APPLICATION NO.	F	FILING DATE	FIRST NAMED INVENTOR	ATTORNEY DOCKET NO.	CONFIRMATION NO.
10/777,161	02/13/2004		Toshiyuki Masuda	023484-0158	5102
22428	7590	01/12/2006		EXAMINER	
FOLEY AN	ND LAR	DNER LLP	BINDA, GREGORY JOHN		
SUITE 500 3000 K STR	EET NW	,		ART UNIT	PAPER NUMBER
WASHINGTON, DC 20007				3679	
				DATE MAILED: 01/12/2006

Application No.	Applicant(s)			
		10/777,161	MASUDA, TOSHIYUKI			
	Office Action Summary	Examiner	Art Unit			
		Greg Binda	3679			
The MAILING DATE of this communication appears on the cover sheet with the correspondence address Period for Reply						
A SHORTENED STATUTORY PERIOD FOR REPLY IS SET TO EXPIRE 3 MONTH(S) OR THIRTY (30) DAYS, WHICHEVER IS LONGER, FROM THE MAILING DATE OF THIS COMMUNICATION. - Extensions of time may be available under the provisions of 37 CFR 1.136(a). In no event, however, may a reply be timely filed after SIX (6) MONTHS from the mailing date of this communication. - If NO period for reply is specified above, the maximum statutory period will apply and will expire SIX (6) MONTHS from the mailing date of this communication. - Failure to reply within the set or extended period for reply will, by statute, cause the applicatio

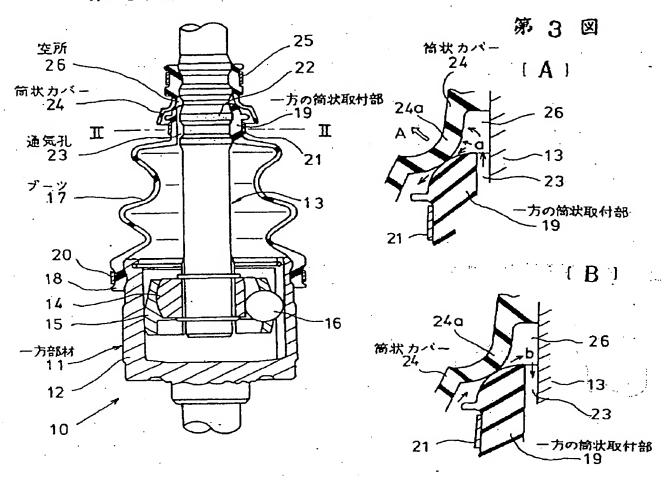
6. Claims 1, 5, 6 & 8-10 are rejected under 35 U.S.C. 102(b) as being anticipated by JP 61-117921. Figs. 1-3 show a universal coupling comprising all the limitations of the claims. Fig. 3A shows a first air bleeding passage/groove 23 formed in the cylindrical wall of the end 19 of the boot 17 and arrow A indicates the inside end surface of the cover 24 expands so as to define a second air bleeding passage. See also the last paragraph on page 5 of the English language translation of JP 61-117921.

Fig. 3 shows the leading lip of the boot cover 24 is formed with effectively one groove, not a

plurality of grooves. However, making the leading lip portion with a plurality of such grooves

would have been obvious at the time of applicant's invention, since such a modification would

have involved a mere duplication of parts. The duplication of parts for a multiplied effect has no

patentable significance and is considered well within the purview and obvious to one of ordinary

skill in the art. St. Regis Paper Co. v. Bemis Co., Inc. 193 USPQ 8, 11 (7th Cir. 1977).
